NSD-NRC-96-4814
DCP/NRC0598
Docket No.: STN-52-003

SUBJECT: AP600 LOFTRAN COMPUTER CODE ISSUE RESOLUTION

The attachment to this letter provides responses to NRC Supplemental Draft Safety Evaluation Report (SDSER) open items related to the LOFTRAN computer code and its application to AP600 safety analyses. The SDSER open items addressed in this letter are 21.6.1.4-1, 21.6.1.6-1, 21.6.1.7-1, 21.6.1.7-2, 21.6.1.7-3, 21.6.1.7-4, 21.6.1.7-5, 21.6.1.7-6, 21.6.1.7-7, 21.5.4-1, 21.5.4-2 and 21.5.4-3.

Figure 5 - CVS Malfunction Transient, Mass and Energy Balance

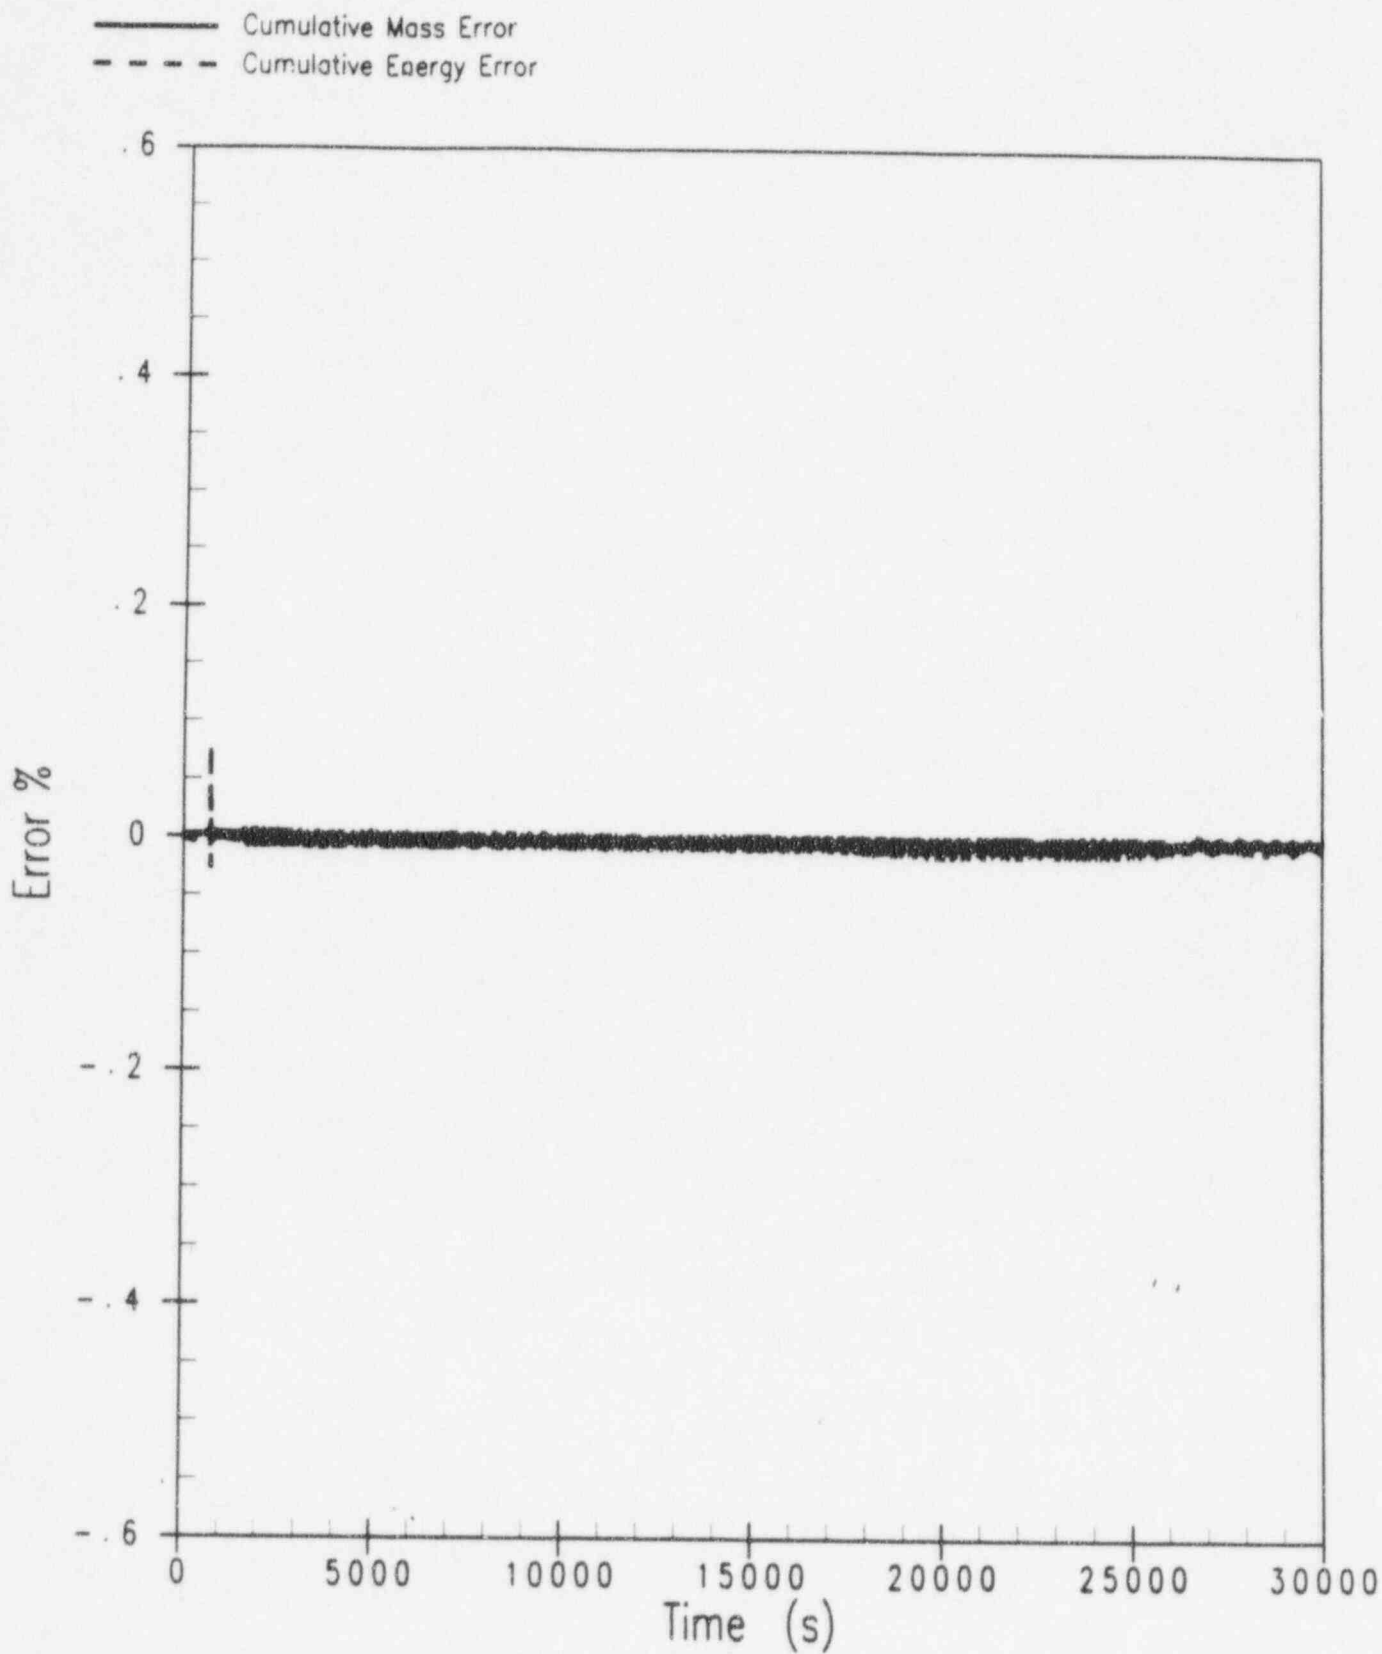
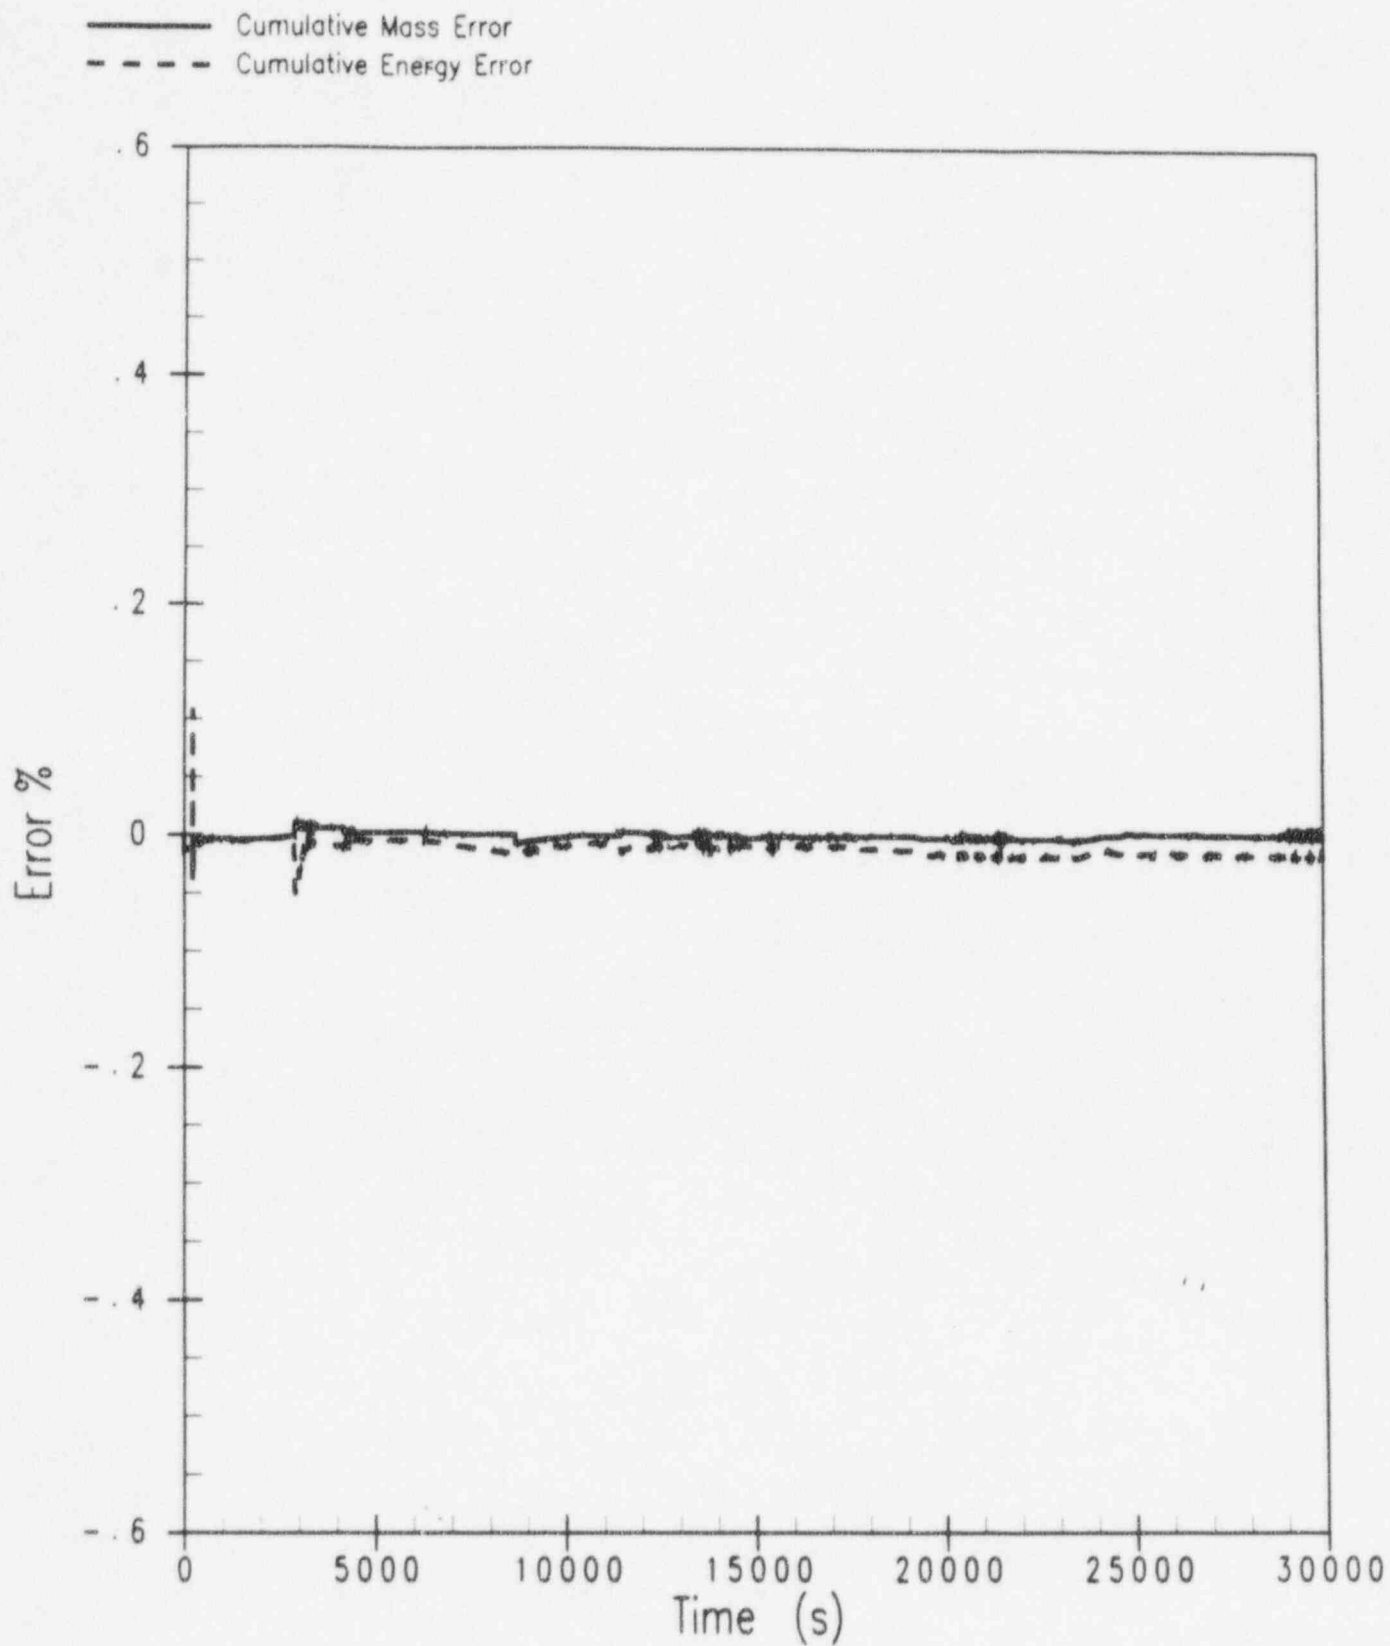
For each transient analyzed with LOFTRAN, Westinghouse needs to submit information on the impact of not conserving mass, energy, momentum, and volume.

Mass and energy balances were performed (using the methodology described in the response to RAI 440.288) to verify that the LOFTRAN/LOFTTTR2 codes used for the AP600 non-LOCA and SGTR analyses conserve mass and energy with a reasonable degree of accuracy. Mass and energy balances were performed for a transient from each of the six main design basis accident sections of the SSAR where LOFTRAN is used. The results of these calculations are presented in Table 1, which shows that there is no appreciable mass or energy error developed for any of the LOFTRAN transients. Figures 1-6 present the transient mass and energy balances for the selected transients.

Figure 3-1

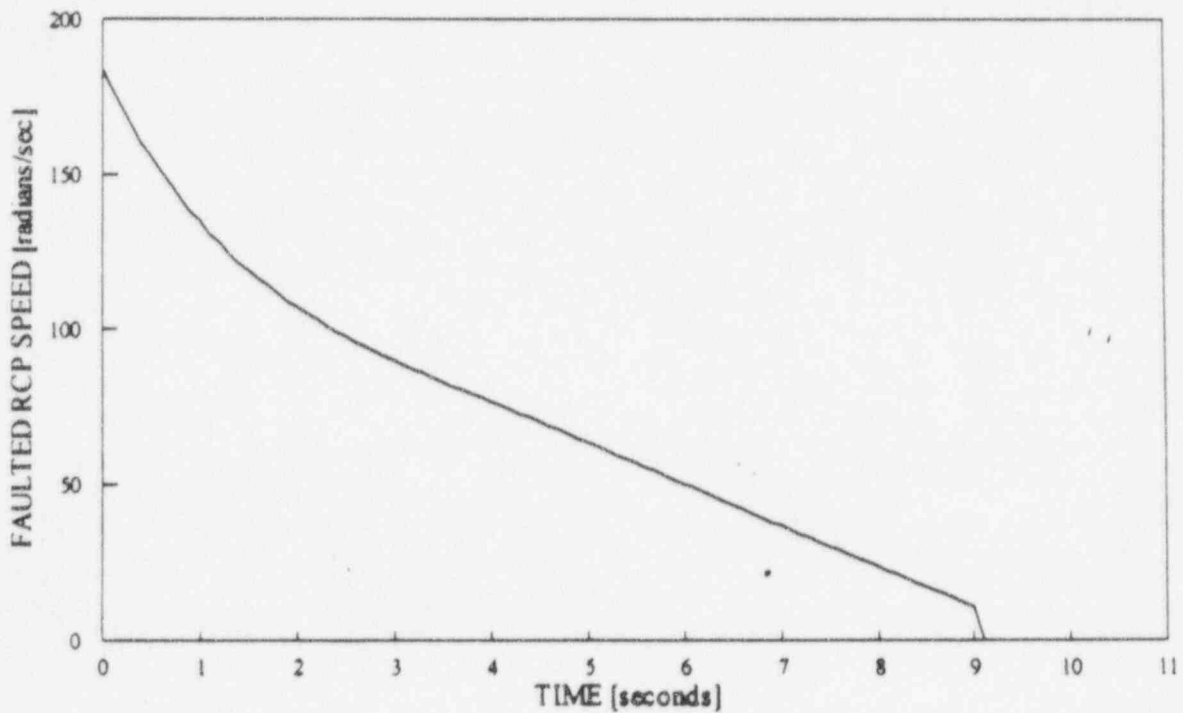
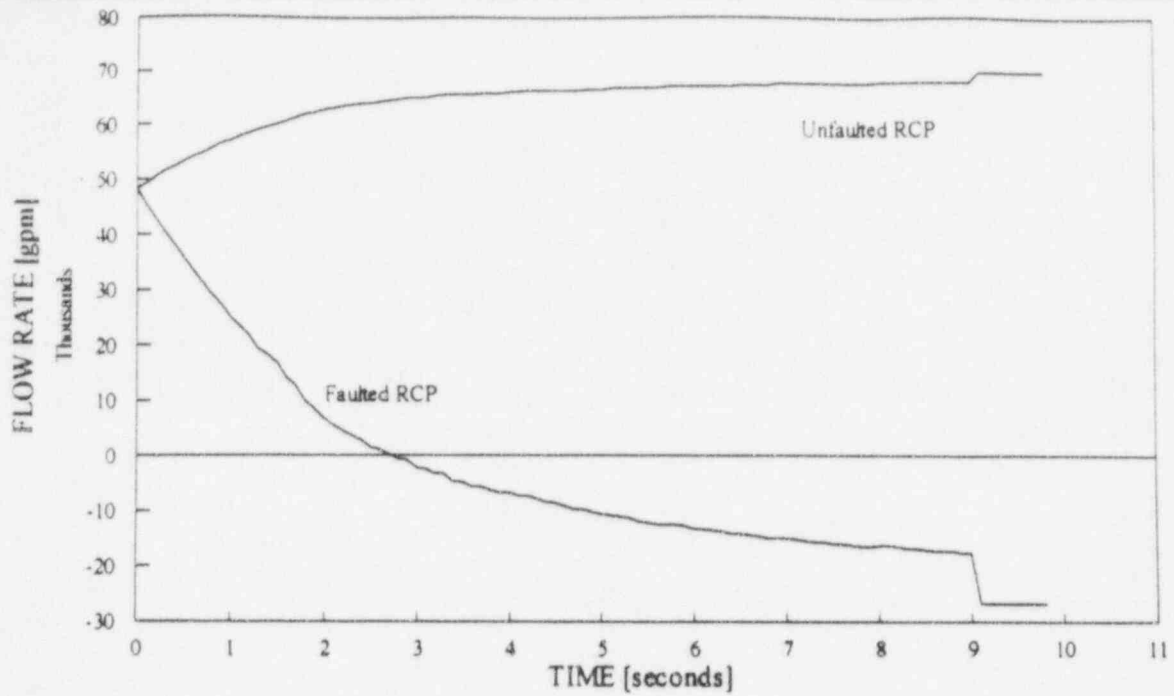
Westinghouse needs to submit a detailed example of how it used auxiliary programs, hand calculations, and conservative assumptions to model pump trips and startups in LOFTRAN.

In the transient analyzed, reactor coolant pumps 1B and 2B (see Figure 2-1) are assumed to start coasting down at time equal 0.0 seconds. Reactors coolant pumps 1A and 2A are assumed to remain running at nominal operating speed. The results from the calculations are shown in Figure 3-1. As shown in Figure 3-1 the reactor coolant pump coasts down in ~ 9 seconds.

At low reactor coolant speeds, the bearing friction is the dominant force slowing the pump. Bearing friction torque drops with the square root of pump speed. At low a speed of 5% it is assumed that the bearings approach contact and rubbing resistance is increased to the point at which the pump is stopped. In the case analyzed this occurs at 9.1 seconds and is illustrated in Figure 3-1.
